Access Compliance Report Public Rights-of-Way (Curb Ramps)

Main Street: HEWES_ST Cross Street: E_CHAPMAN_AVE Location: NE

ADA ID: RPRK211223132359 Ramp Type: Type 1 - Perpendicular Initial Pass/Fail: Fail Overall Compliance: No Severity Score: 16

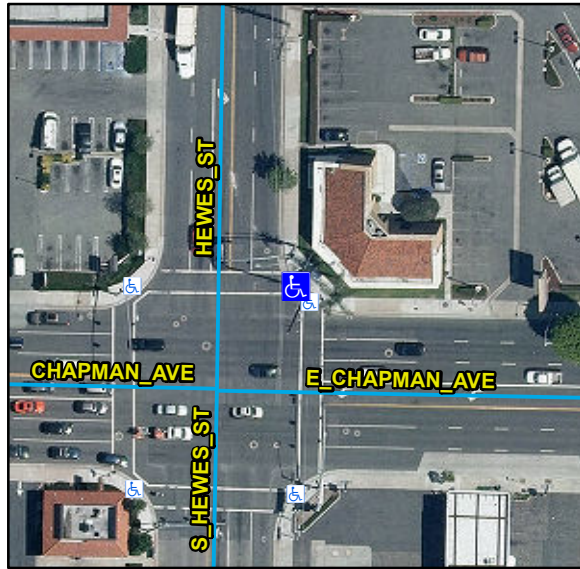
Compliance	Description	Data	Compliance	Description	Data
N/A	Ramp Length (in)	83	N/A	Flare Type LT	
Yes	Ramp Width (in)	48			N/A
No	Ramp Run Slope (%)	8.8	N/A	Flare Slope LT (%)	N/A
Yes	Ramp Cross Slope (%)	1.2	N/A	Flare Traversable LT	N/A
N/A	Landing Present	N/A	N/A	Flare Type RT	
N/A	Landing Length (in)	N/A			N/A
N/A	Landing Width (in)	N/A	N/A	Flare Slope RT (%)	N/A
N/A	Landing Run Slope (%)	N/A	N/A	Flare Traversable RT	N/A
N/A	Landing Cross Slope (%)	N/A	N/A	DWS Provided	N/A
N/A	Landing Movement Obstructed?	N/A	N/A	DWS Contrast	N/A
	Landing Movement Type	N/A	N/A	DWS Length (in)	N/A
N/A	Landing Shared	N/A	N/A	DWS Full Width	N/A
N/A	Clear Space	N/A	N/A	DWS Offset Left (in)	N/A
N/A	Clear Space To Crosswalk (in)	N/A	N/A	DWS Offset Right (in)	N/A
N/A	Marked Crosswalk 1	Yes	N/A	Marked Crosswalk 2	N/A
	Crossing 1 Direction	W		Crossing 2 Direction	N/A
	Marked Crosswalk 1 Width (in)	120		Marked Crosswalk 2 Width (in)	N/A

Remove & Replace Entire Ramp.

R304.2.2, STD 1115
